UNITED STATES PATENT AND TRADEMARK OFFICE  
**CERTIFICATE OF CORRECTION**

PATENT NO. : 7,349,226 B2  
APPLICATION NO. : 10/638982  
DATED : March 25, 2008  
INVENTOR(S) : Ice

**Fig. 1**

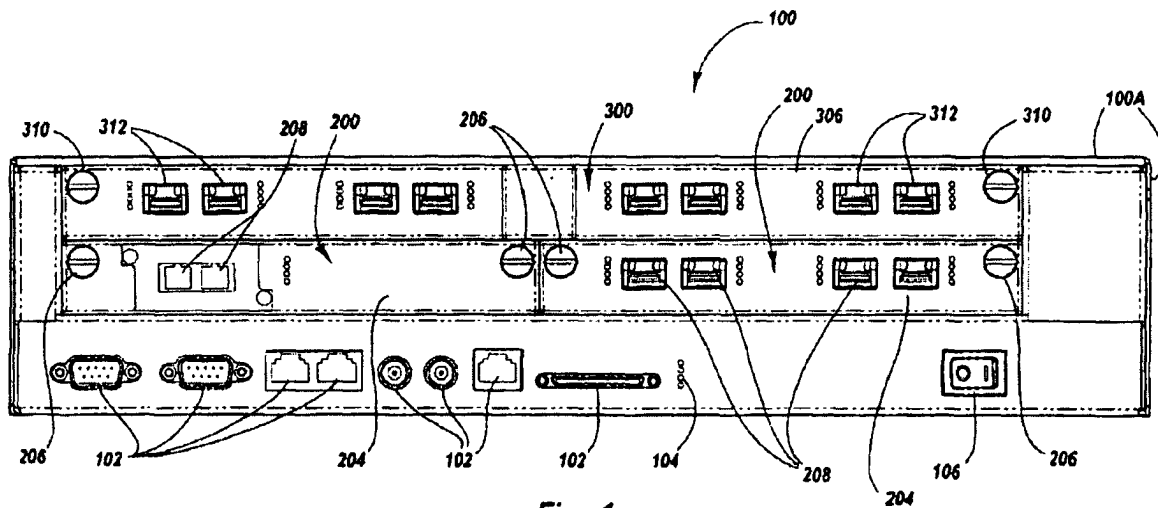
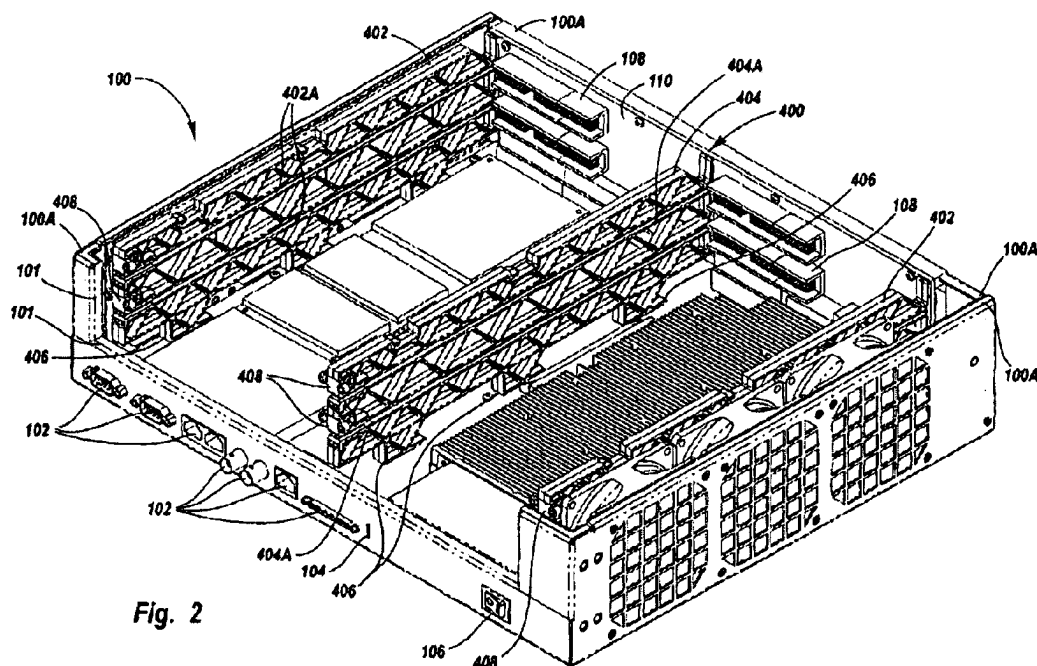
Sheet 1, replace Figure 1 with the figure depicted below, wherein the connectors 306 have been relabeled 312

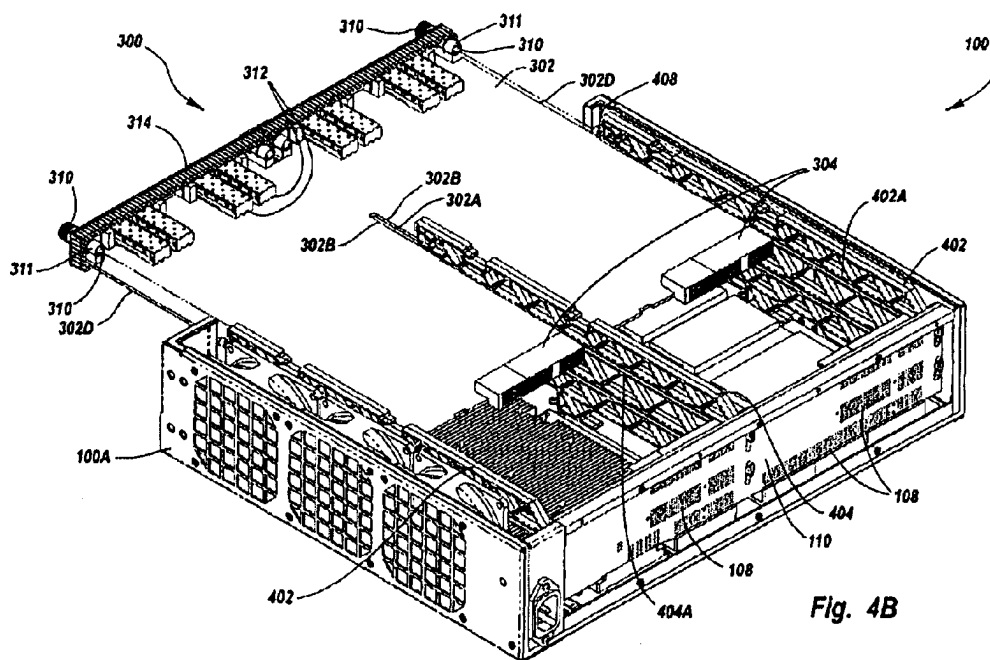
Sheet 2, replace Figure 2 with the figure depicted below, wherein the channel 404G has been relabeled 404A
